## **LANDSCAPE ASSESSMENT**

### **SOUL FRIENDS PET CREMATORIUM 94 MULGRAVE STREET**

September 2021

1. The following assessment of landscape character and visual effects was commissioned by Palmerston North City Council to review the Landscape and Visual Assessment which accompanied an application for resource consent for a proposed crematorium. The Landscape and Visual Assessment, dated 18 December 2020, was prepared by WSP hereinafter referred to as the “**Landscape Assessment**” (Figure 1).
2. The proposal is located at 94 Mulgrave Street, Ashhurst. The 4-hectare site is legally named Lot 2 DP 35100 and held in Record of Title WN12A/55.

Figure 2: Elevation view of TotalSpan shed. Sourced from the Landscape Assessment. Note: the 10.5m high cremator stacks were excluded from this drawing so the height of these have been indicatively annotated.

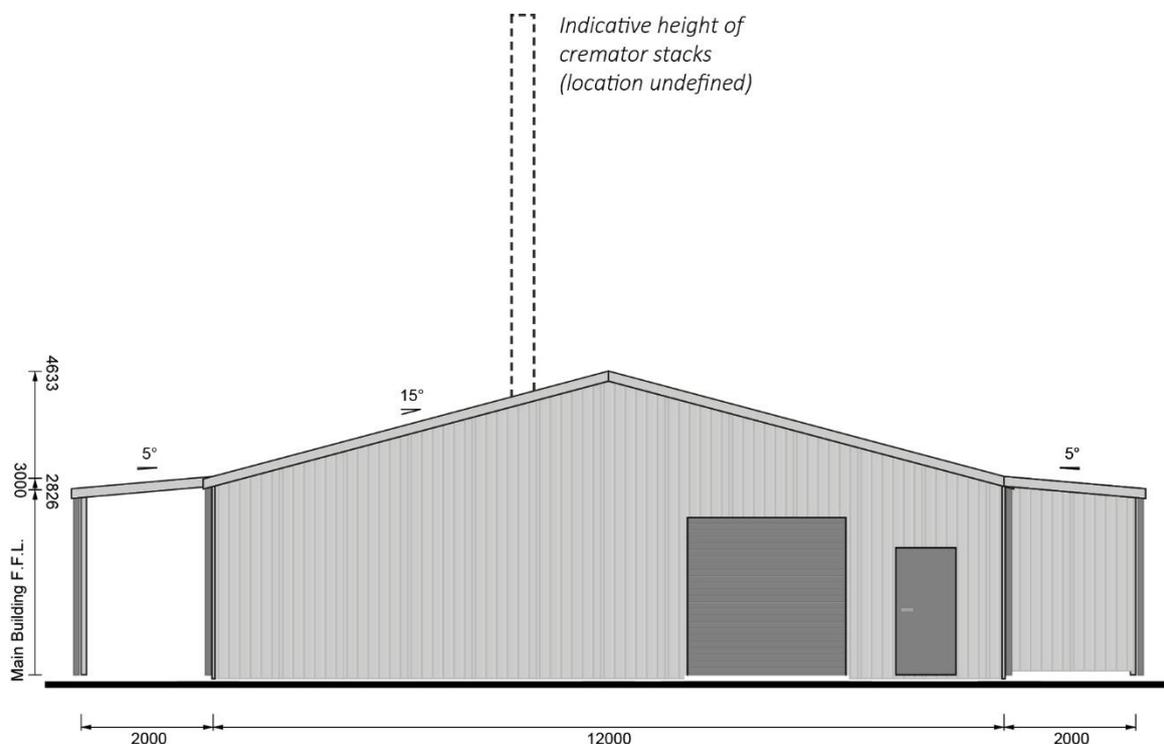
38. The visual dominance of four cremator stacks will be less effectively mitigated, compared with the rest of the structures. While dark colours (i.e., Resene Karaka or Resene Flaxpod) generally minimise the bulk of the structure, this will have the opposite effect for the 10.1m vertical elements which will, in some instances, extend above the vegetation into the skyline. This visual change will be most noticeable to neighbouring residents with low fences and limited planting. In saying that, tall and thin vertical elements are not uncharacteristic within the broad and localised context. As a result, this modification is immaterial in terms of the landscape character. This is considered a **low** effect. The adverse effect associated with the visibility of these stacks are primarily attributed to the negative connotation's locals may ascribe to crematoriums.

- Materiality (use of low reflective, dark green or black colour finishes intended to minimise the prominence of built forms).
43. To further reduce effects on surrounding residents we considered the option of using lighter colours with low reflectivity for the cremator stacks. This would help to blend the vertical elements into the sky (similarly to wind turbines on the ridges) from certain angles. However, an unintended consequence for this would be that these vertical elements would become more prominent from viewpoints where the Tararua and Ruahine Ranges act as a backdrop. Given that appreciation of ONFL's is fundamental to the landscape character, we do not recommend the use of lighter colours for the cremator stacks.

Figure 3: Site Plan.

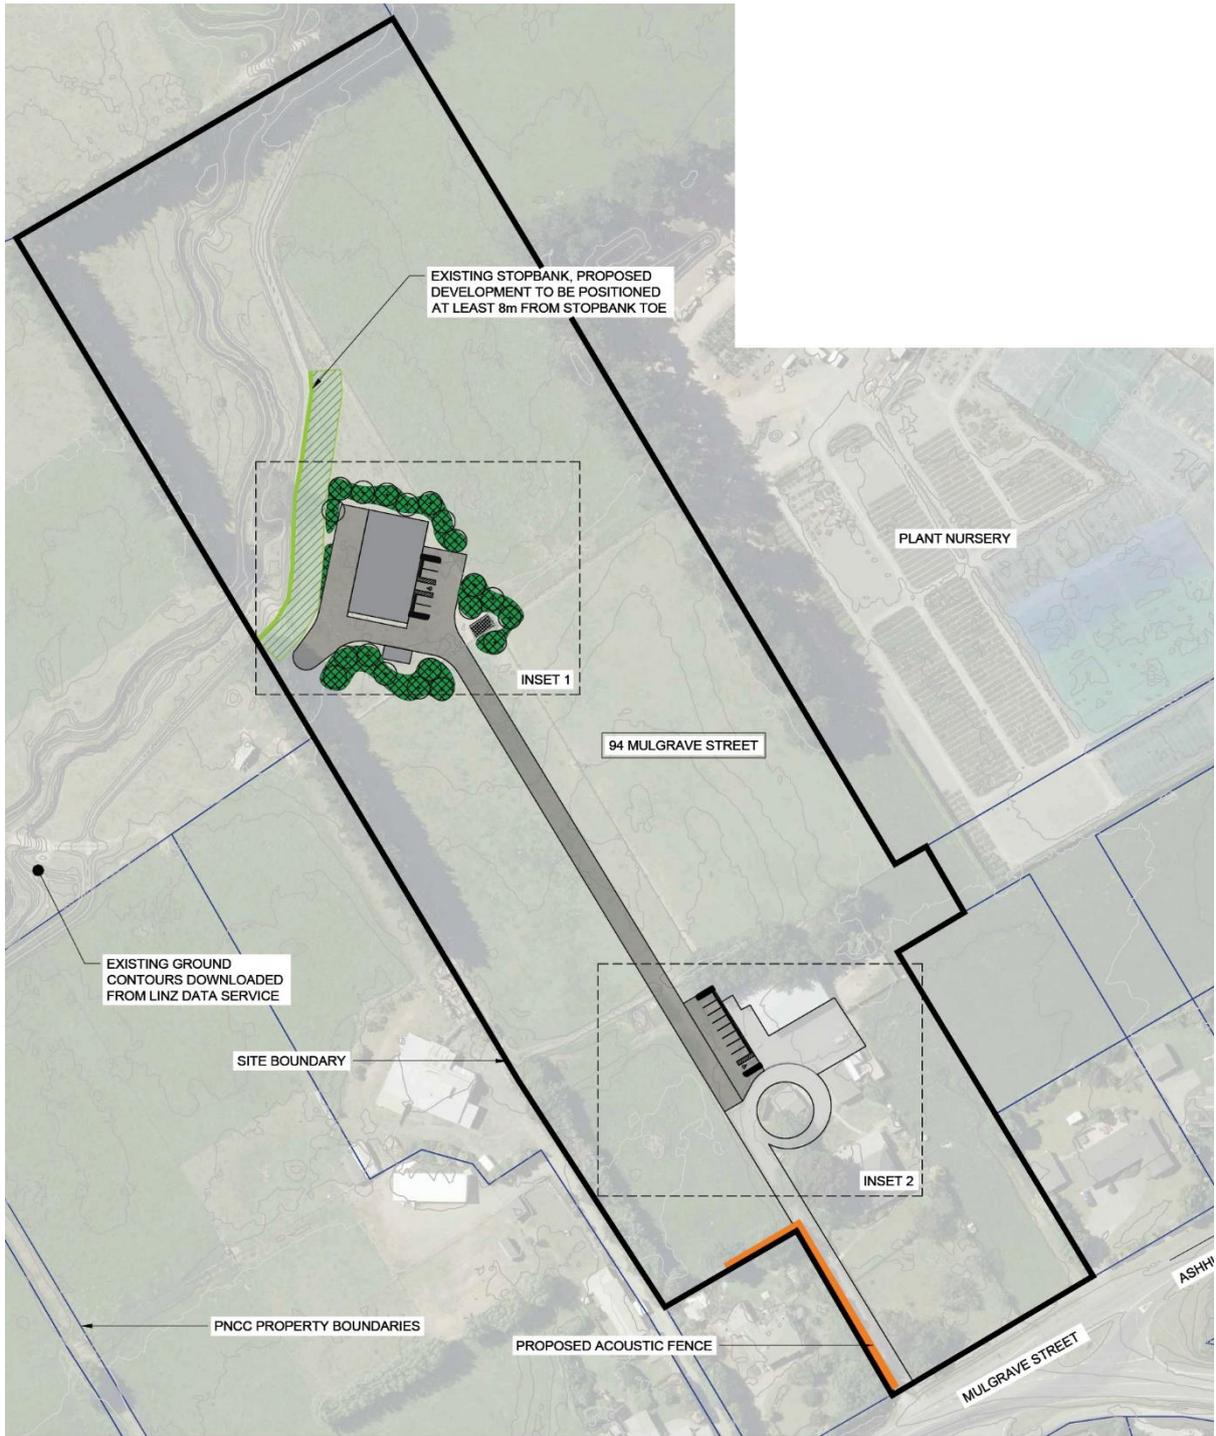
36. Due to the potential for negative connotations with crematorium, friction arises between the proposed activity and residential landuse near the site. To avoid adverse effects of the crematorium on residential sensibilities, the crematorium building is located at the rear of the site, setback at least 190m from residential properties to the south. Open space is proposed on-site, and the existing shelter belt and trees are to be retained, which will provide a buffer between these potentially conflicting activities. This will reduce the visual effects of the proposal during construction, and while the mitigation planting is being established. Given these considerations, while the activity will be unobtrusive due to mitigation measured (see [Integration of Built Form](#)), **low** effects arise due to the heightened sensitivity of residents. In extreme instances, effects may be **low-moderate** at most.

37. The scale and form of the proposed building is in-keeping with the rural context. Surrounding the site, the landscape predominantly displays a rural aesthetic. Structures are typically utilitarian, such as farms sheds, fencing, and powerlines amongst pervasive vegetation. The proposal building is a TotalSpan shed which is a built form anticipated in the rural zone. The proposed screening planting around the building will further integrate the built form into the broader and local rural
